Architectural Centre Response to WCC Report

The Architectural Centre considers the WCC's "Basin Reserve - Assessment of Alternative Options for Transport Improvements" to be biased at a number of levels.

Fig 1: Views of the Carillon from Kent & Cambridge Terraces; Bottom view including Option X

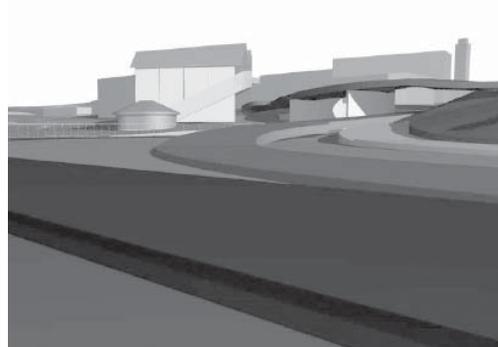
3. There appears to be a bias towards Option A. At times this is integral to the criteria (e.g. the inclusion of Option A in the Regional Land Transport Programme (p. 42) and that the flyover is currently funded through the National Land Transport Programme (p. 44) automatically rewards Option A in the Strategic Fit Analysis assessment). At other times the bias is less explicit (e.g. there is no acknowledgement that the view of the Carillon will constantly be blocked from ground level view by the undercroft of the Option A flyover (p. 56)), while the evaluation of the same criteria incorrectly claims that the Option X green bridge will block the view of the Carillon (**fig 1**).

4. The analysis of views is fundamentally erroneous. For example, the analysis of views from the Option A flyover does not acknowledge the need for a noise barrier. A noise barrier will block views, negating much of the positive evaluation of the flyover. Best practice sound mitigation usually requires a 3 metre high barrier along motorways, although some places in American suggest sound barriers on motorways of 5 metres (Virginia) and 7.5 metres (Washington). This will be an especially important aspect of the flyover design because the Basin precinct is envisaged by the WCC as one to accommodate increased residential density (and so higher residential buildings), and highway noise is notorious for sleep disturbance.

Fig 8: Sketch design views of possible Option X green bridge

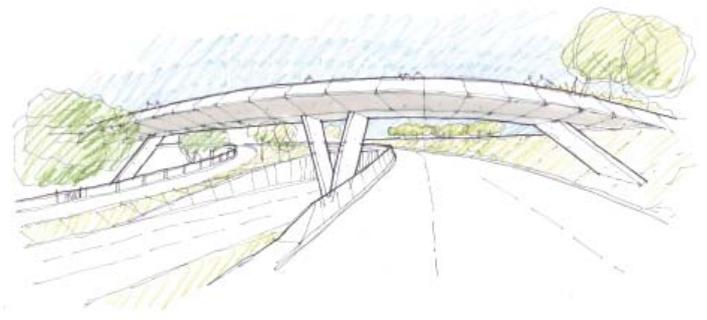
There is no acknowledgement that the Option X green bridge will provide significant elevated views for pedestrians and

cyclists of Memorial Park, Kent/Cambridge Tce and Mt Victoria. The experience of crossing the green bridge will be similar to that experienced crossing the delightful City to Sea bridge in Civic Square (**fig 6**), which crosses six lanes of traffic. Chicago's Millenium Bridge is another possible model for the Option X bridge (**fig 7**).
